City of Plymouth Planning Commission
Regular Meeting Agenda
Wednesday, June 8, 2022 – 7:00 p.m.
City Hall & Online Zoom Webinar

Special Land Use and Site Plan Review For Plymouth, Michigan

Applicant:	Sidecar Plymouth, LLC 340 N. Main St. Plymouth, MI 48170
Project Name:	Sidecar Slider Bar and Shift Bar
Plan Date:	Architectural Plans Cover Sheet – No Date Architectural Plans Sheet A1 – April 27, 2021 Architectural Plans Sheet A2 – February 5, 2022 Architectural Plans Sheet A3 – January 13, 2022 Boundary Survey – April 22, 2022
Location:	320 N. Main St.
Zoning:	B-3 – General Commercial District
Action Requested:	Special Land Use and Site Plan Review approval
Required Information:	Any deficiencies are noted in the report.

LP - 1: LANDSCAPE PLANTING PLAN

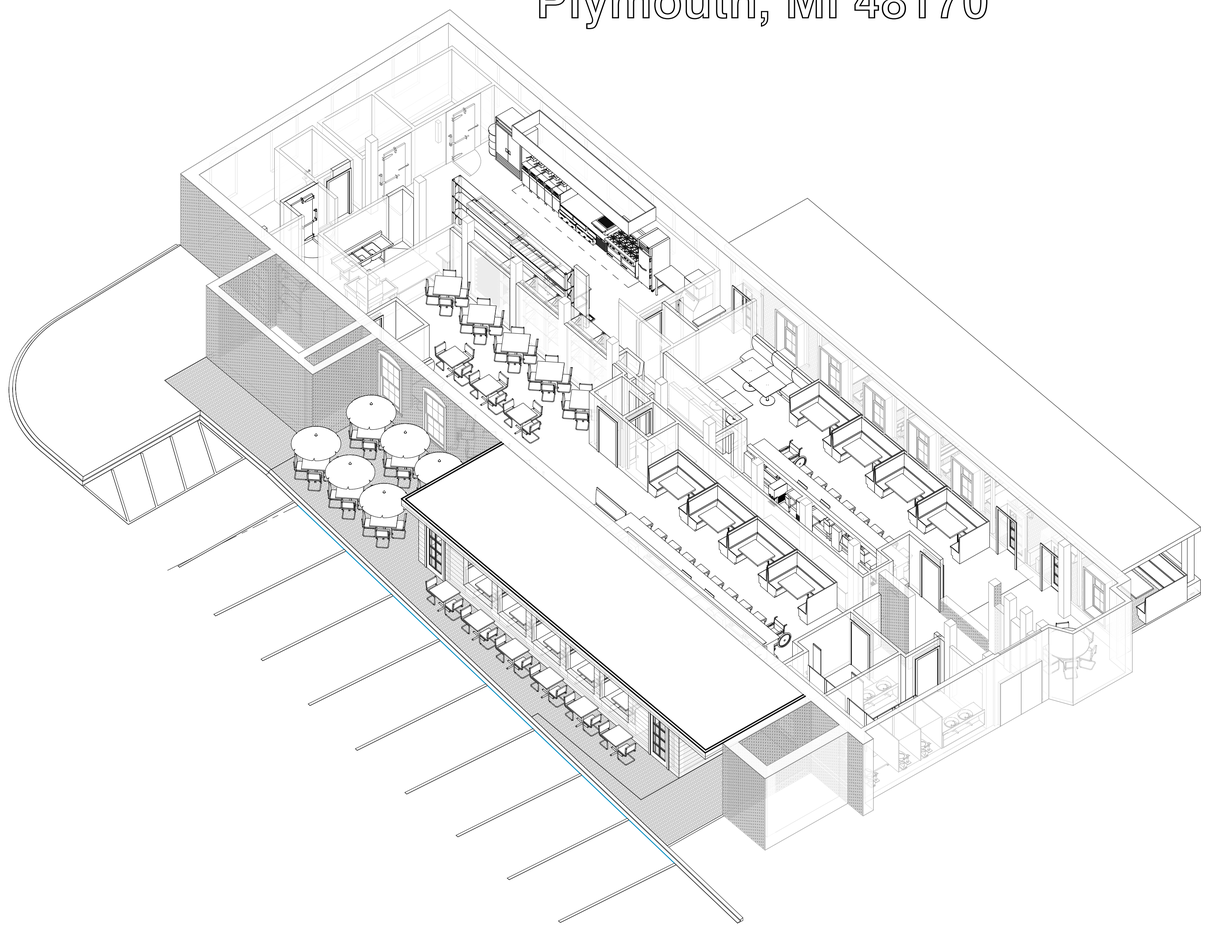
1) The architectural plans show planting boxes along the edge of the easterly patio, but this treatment is not illustrated on the landscape plan, and
2) The landscape plan shows "unit block retaining wall" with plants along the edge of the westerly patio, but this treatment isn't illustrated on the architectural plans.

The architectural plans and landscape plan are not consistent with each other, and need to be so. The architectural plans should be updated as described below.

Five (5) additional trees and seven (7) additional shrubs need to be added to the N. Main St. frontage.

Items to be Addressed: *1. Add five (5) additional trees and (7) shrubs along N. Main St. street frontage planting. 2. Additional landscaping, lighting, dumpster screen may be required if parking lot renovations occupy 25% or more of the lot.*

SHEET #
A1

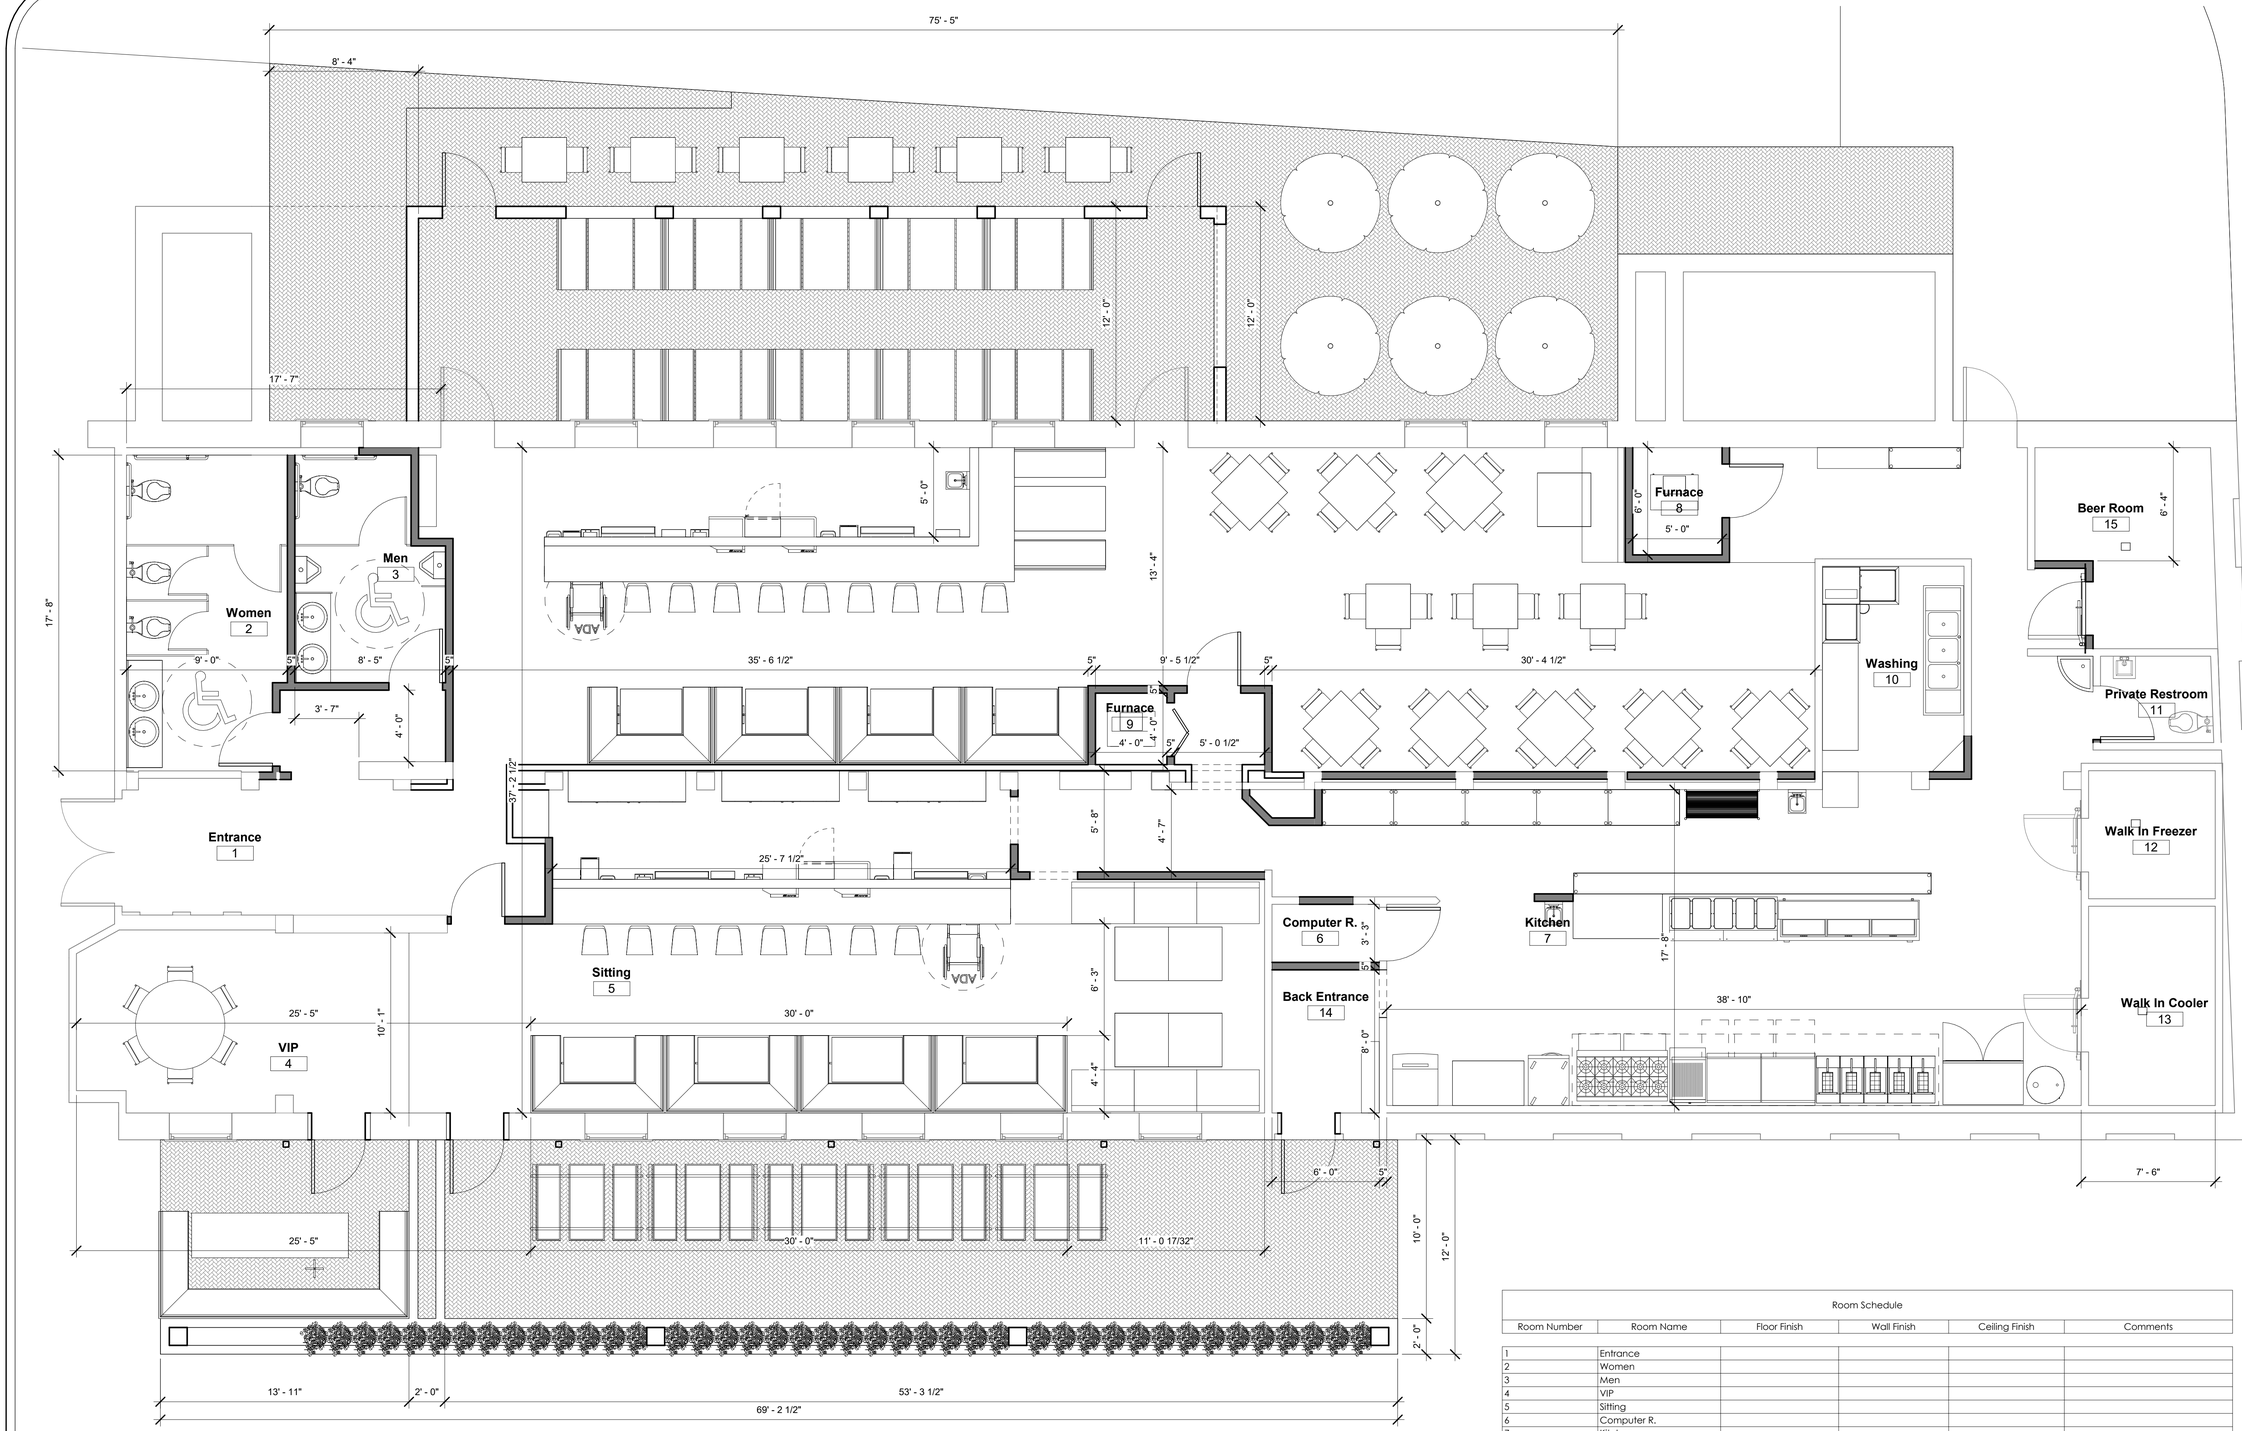
1. No more than ten seats shall be allowed at the bar. *CWA Comment: Sheet A1 shows a floor plan, and indicates both bars will have 9-10 seats.*

2. Alcohol shall be served only to seated patrons or persons standing in the designated standing area as outlined in subsection 78-102(2)(c). *CWA Comment: No standing area is shown on the floor plan, and the arrangement of tables use all the available floor space, except for circulation aisles.*

3. The standing area adjacent to the bar shall not exceed 150 square feet. *CWA Comment: No standing area is shown on the plans.*

4. No dance floor or dancing area allowed. *CWA Comment: No dance floor or dancing area is shown on the plans. Again, the table arrangement takes up the available floor space.*

NORTH OCCUPANCY DIAGRAM TOTAL OCCUPANCY: 175 OCC.

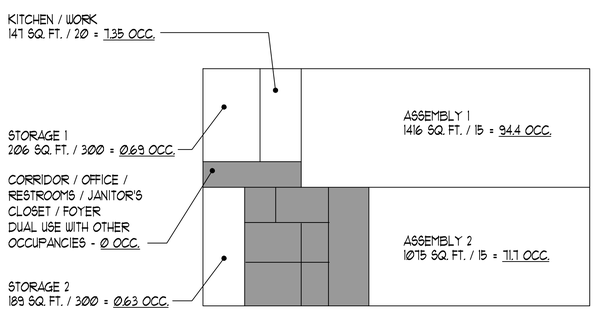
1. No more than ten seats shall be allowed at the bar. *CWA Comment: Sheet 3 shows a floor plan, and indicates the bar will have 10 seats.*
